Submissions Report

Waterloo Mixed Use Development 881-885 Bourke Street
(SSD-80441462)

12 June 2026 | 2240721

Figure 6 Comparison in Tower Height Reduction from SSDA Submission and Amended Plans

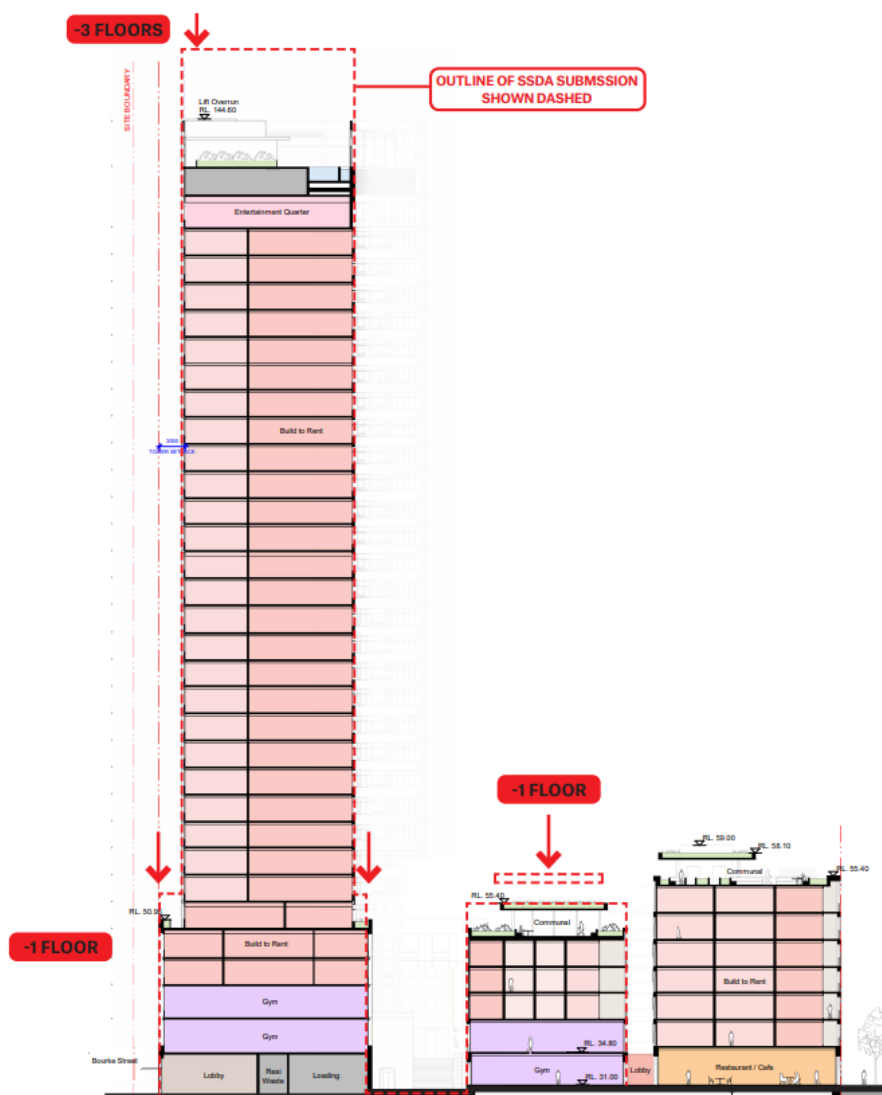
In response to DPHI's comments, the proposed tower height has been reduced from 36 to 33 storeys, as shown in **Figure 6**.

This amendment improves alignment with the surrounding context while maintaining the capacity to deliver well-located housing. The revised number of storeys would result in a parapet height of 144.4m RL or approximately 114.4m from natural ground level. It is noted that the parapet (lift overrun) has a height of 144.6m RL and is limited in area only comprising small portion of the tower floorplate, with the roof height being at 142.5m RL. The parapet comprises a combination of glazing and structural support elements, and the roof of the lower RL is the rooftop amenities/pool area.

Figure 7 Comparison of Concept DA, Revised Concept DA and SSDA Scheme

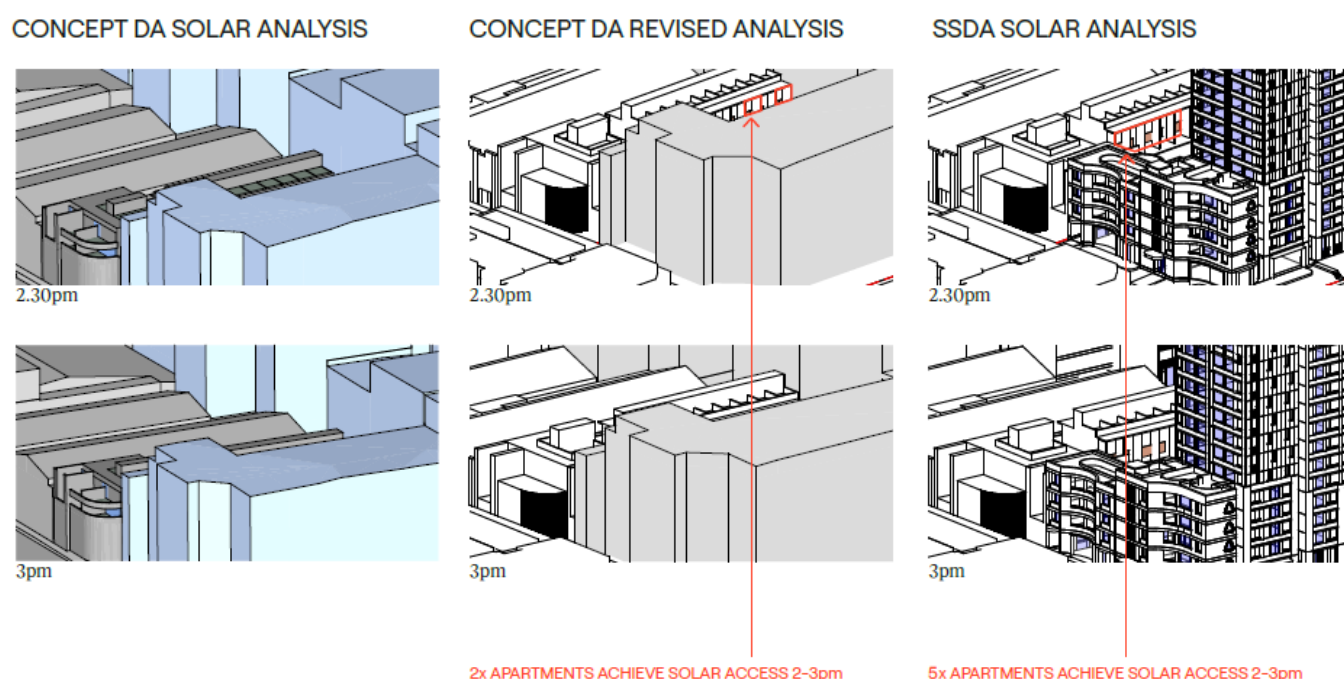
Detailed site investigations, including verification through drone photography, indicate that the massing adopted in the Concept Plan (which informed Condition 83(k)) did not fully account for the height and extent of existing party walls between apartments. These built elements contribute to existing overshadowing of living room windows during winter.

A comparative “eye of the sun” assessment (**Figure 7**) demonstrates that the SSDA scheme improves solar access during this period when compared to the approved Concept DA. On this basis, no further changes to the building massing for this parcel are proposed in response to this issue.

Figure 9 Comparison of Building 2A height from SSDA (left) and Amended Plans (right)

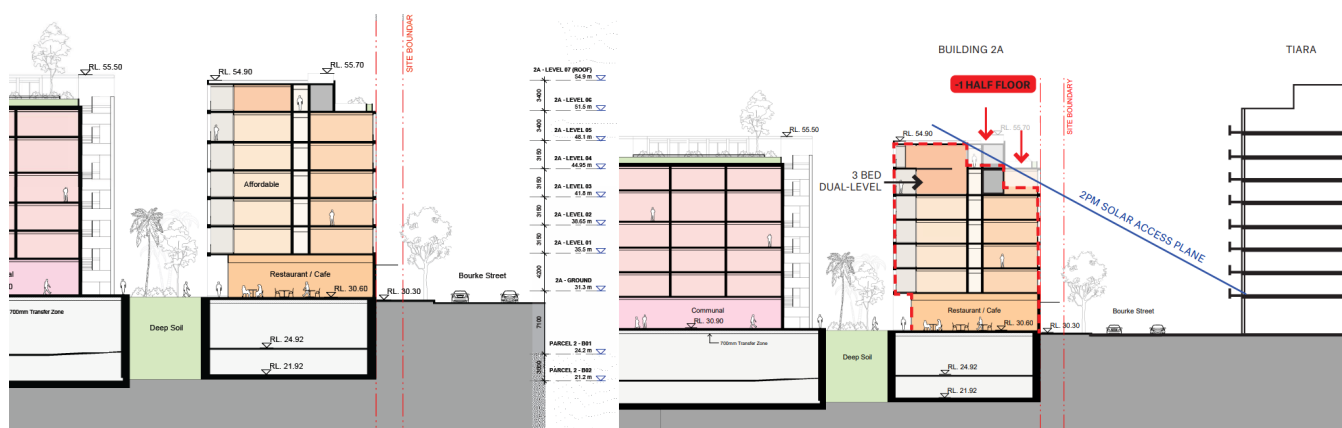
Testing of the proposed scheme initially identified non-compliance with this requirement, particularly affecting first floor apartments. In response, the height of Building 2A was reduced by one storey to mitigate overshadowing impacts, as shown in **Figure 9** below.

As amended, all dwellings fronting Bourke Street retain a minimum of 2 hours of solar access, with the exception of the three dwellings on Level 1, which experience a reduction of less than 20% and are therefore consistent with the City's documentation guide.

Figure 11 Comparison of Concept DA vs Proposed under SSDA vs Proposed Amended Scheme

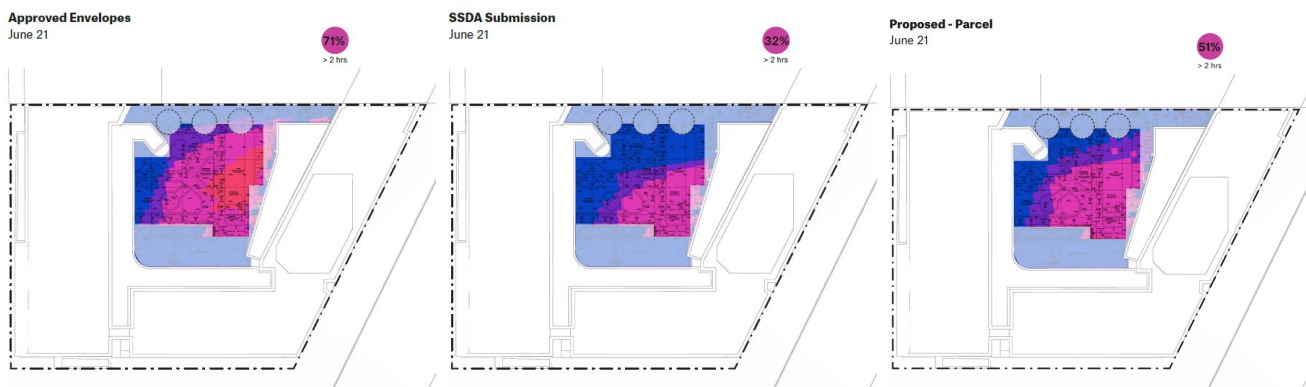
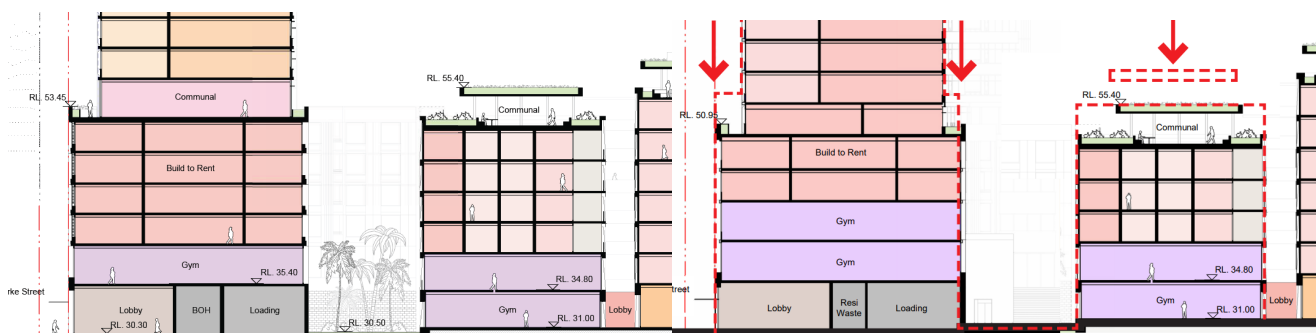
Notwithstanding the above, the proposed SSDA scheme initially resulted in additional overshadowing to the City West Housing Boronia Apartments communal open space (refer **Figure 11**).

To address this, the scheme has been amended to reduce podium-level heights of Buildings 3A and 3B. As demonstrated in **Figure 12**, these amendments protect solar access to the adjoining communal open space and ensure compliance with the *Documentation Guide*.

Figure 15 Building Separation between Parcel 1 and 2

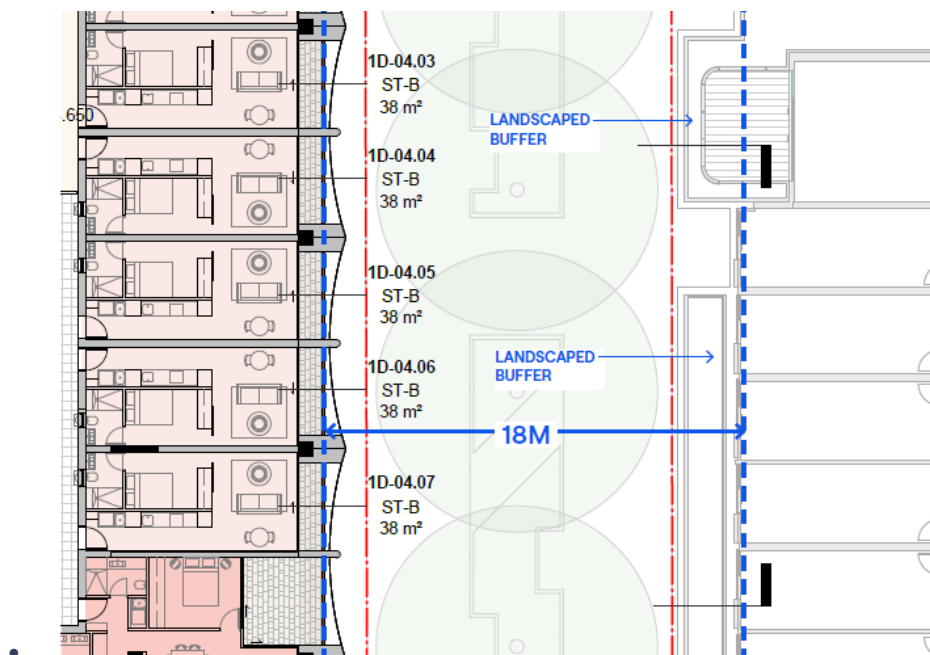
While the overall building envelopes at Levels 4–5 do not achieve the minimum 18m separation, this distance is achieved when measured between the balconies on Parcel 1 and the glazing line on Parcel 2, as shown in **Figure 15**. The zone between the glazing line and the building edge is proposed to be densely landscaped to mitigate overlooking and privacy impacts.

Figure 18 Proposed Privacy Fins

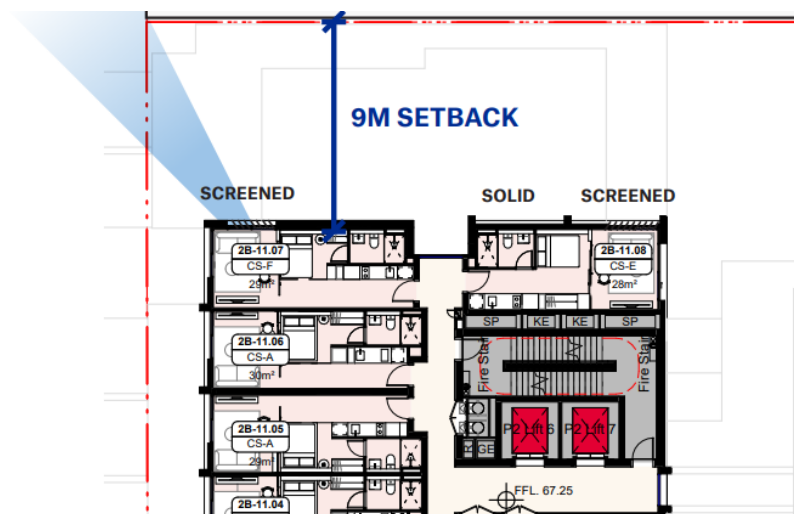
Separation from Building 2B to the North

Additional screening has been introduced to the northern façade of Building 2B to maintain visual privacy to any future development adjoining the building.

Figure 19 *Average Setback to the South*

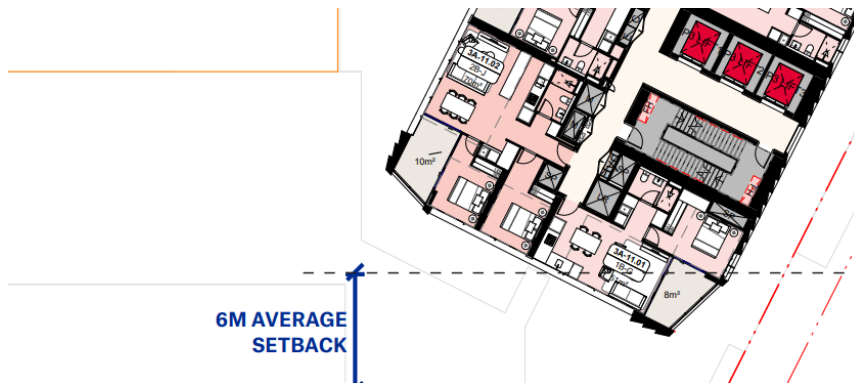
The southern façade of the tower provides an average setback of 6m to the southern boundary, as shown in **Figure 17**. Due to the slope of the land, the tower sits lower than the adjoining building, resulting in a perceived building separation equivalent to approximately four storeys rather than five. Both the City West building and the development on the corner of the tower are oriented to the street, and the development does not have any windows fronting the common boundary, resulting in compliance with the ADG.

Figure 20 *Ground Floor Ceiling Cross Sections*

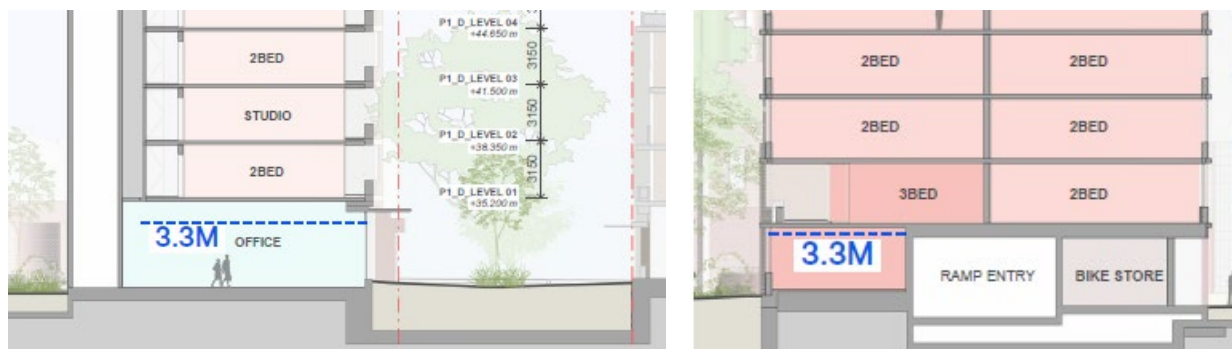
DPHI noted that the development proposes floor to ceiling heights for ground floor uses of 3.2m and first floor uses of 2.7m generally. It was noted that the ADG requires 3.3m for ground and first floors of mixed-use areas to promote future flexibility and adaptation.

The proposed ground floor ceiling heights exceed the minimum 3.3m requirement, as shown in the below sections, supporting activation and future flexibility at street level. While first floor levels do not achieve a 3.3m floor-to-ceiling height, this is considered appropriate in the context of a build-to-rent scheme, where long-term residential use is anticipated and future commercial adaptation is unlikely. The provision of communal facilities across multiple levels introduces flexibility within the building to accommodate evolving resident needs.

Figure 23 *Flood Hazard PMF with Climate Change*

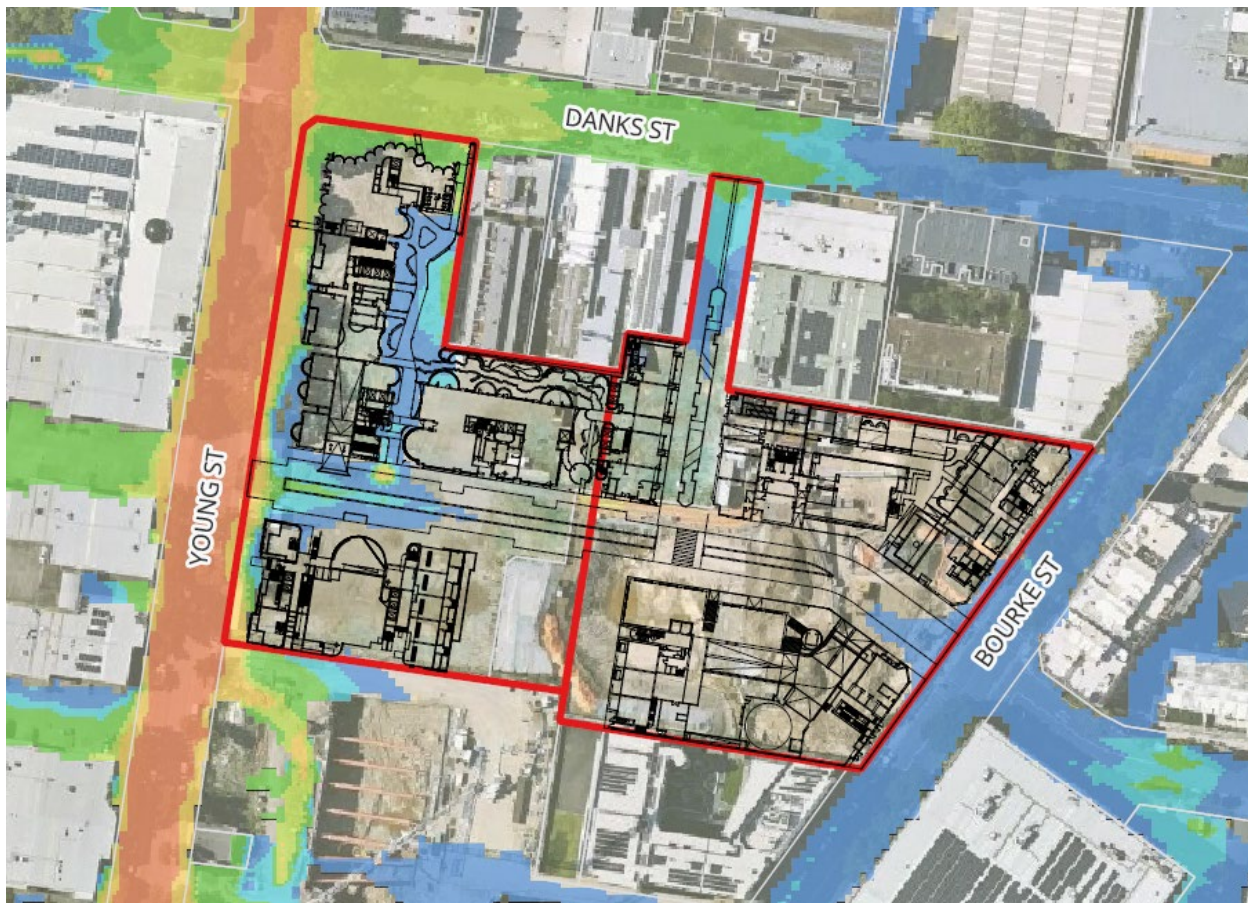
During the PMF and PMF with climate change events, shown in **Figure 23** below, the assessment indicates that future residents and visitors may be required to traverse low hazard (H1) floodwaters and undertake short-term shelter-in-place measures (less than six hours). This outcome represents a moderate level of consequence.

A Flood Emergency Response Plan (FERP) has been prepared to address these scenarios, outlining appropriate emergency response procedures and identifying any mitigation measures required during extreme flood events.

Figure 24 Emergency Egress Route

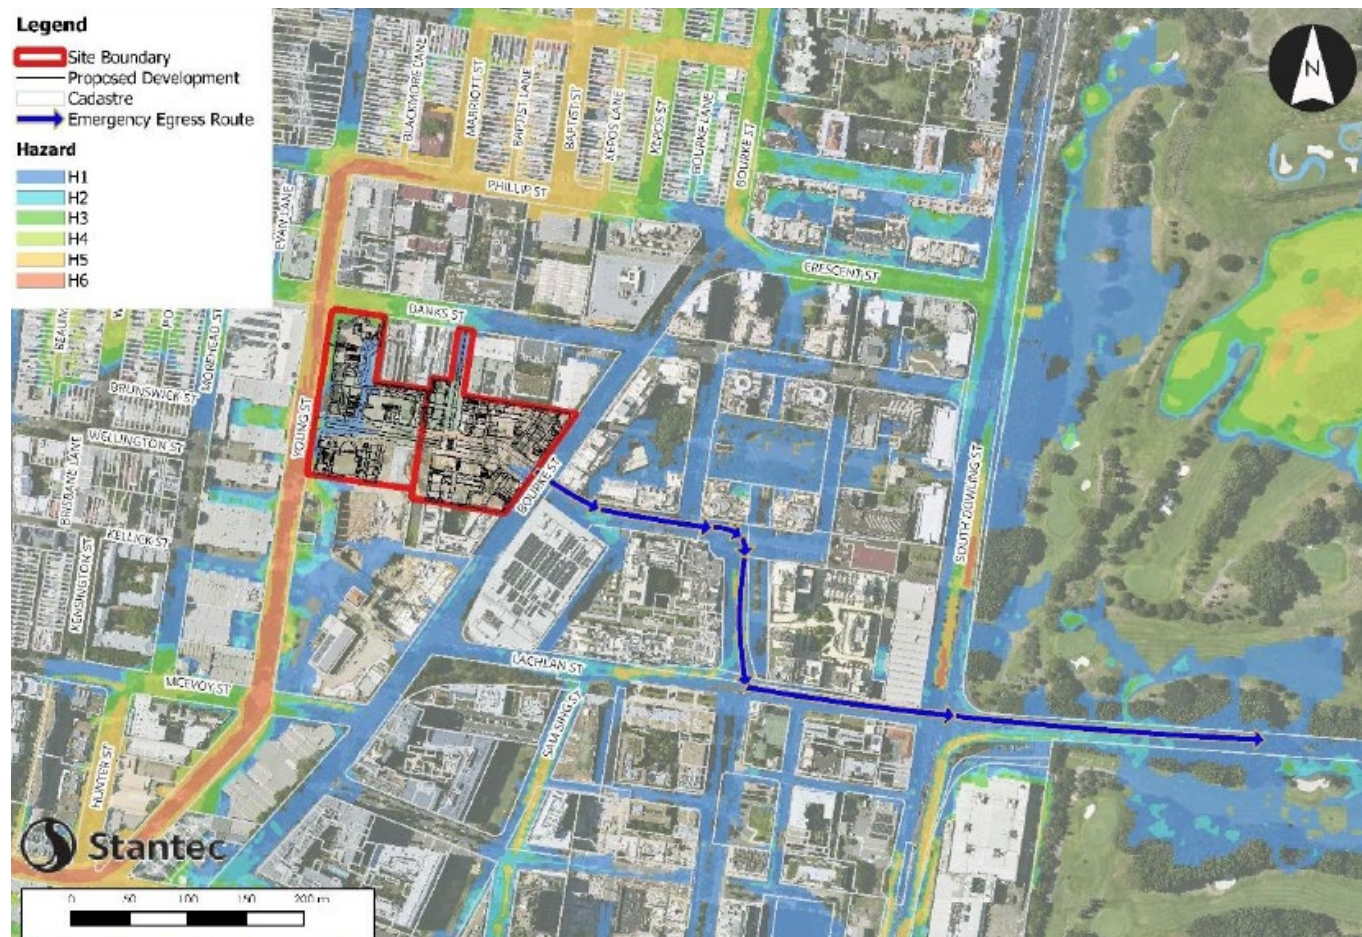
The FERP notes that while broader flood planning frameworks, including the State Flood Plan, typically prioritise evacuation as the primary response, evacuation is not recommended in this instance. The rapid onset of flooding results in limited warning time (less than one hour), which is insufficient to enable safe evacuation prior to inundation of surrounding routes. Attempting evacuation under these conditions would expose occupants to an unacceptable level of risk. In addition, off-site evacuation via Bourke Street may be compromised during the PMF, particularly for occupants within Parcel 1 in the north-west portion of the site. During this event, flood hazard within the site is predicted to reach category H5, with higher hazard conditions to the west (up to category H6), effectively restricting safe access and egress. Accordingly, evacuation is not considered a viable response under these conditions, and a shelter-in-place approach is required.

Nonetheless, an emergency egress route during the PMF is nonetheless available, as shown in **Figure 24** with flood hazard levels generally at H2 (unsafe for small vehicles) or lower, and some isolated, localised areas of higher hazard up to H5. These higher hazard areas are not continuous and can be avoided during emergency movements. The emergency egress route extends from Bourke Street to Potter Street, continuing to Gadigal Avenue, Lachlan Street and Dacey Avenue, which connects to Anzac Parade.
